Conceptual Review Agenda

Schedule for 01/27/14 to 01/27/14

Re: 616 W Mulberry - Bed & Breakfast

Re: 1825 Sharp Point Dr - Charter School

Appendix A

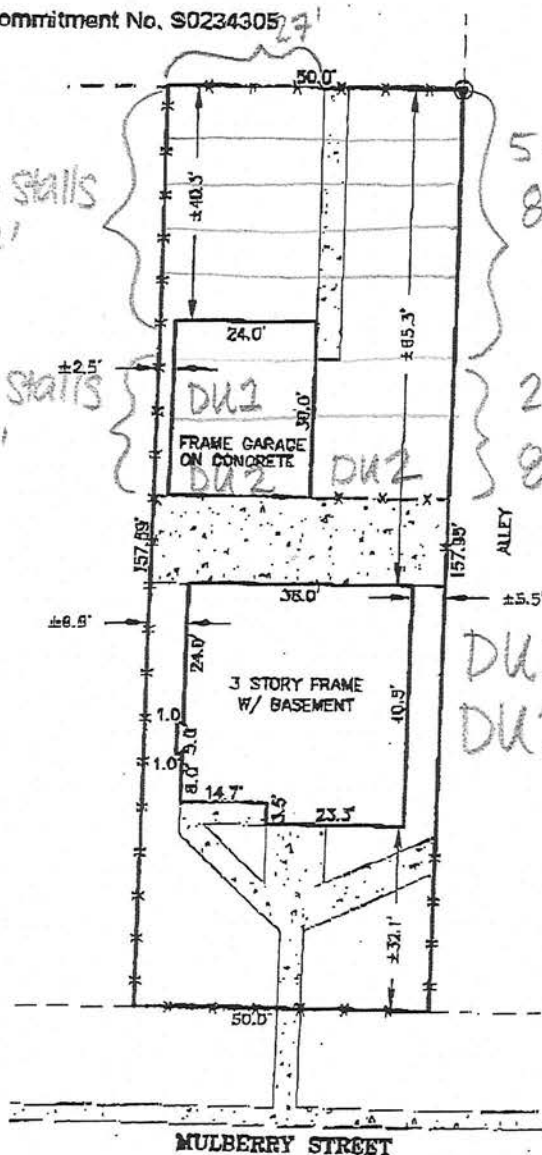
1. How many employees do you have? and where will they park?
2. Tandem parking is not allowed, we cannot include these spaces to meet parking requirements. If you want to pursue the proposed parking layout, a modification to the standard will be required (the standard requires that each parking space have unobstructed access to the street). A 5' wide landscape strip will be required along the north and west lot lines abutting the parking area. 6% of the interior of the parking area needs to be in the form of landscape islands. The parking stalls need to be a minimum of 8.5' in width.
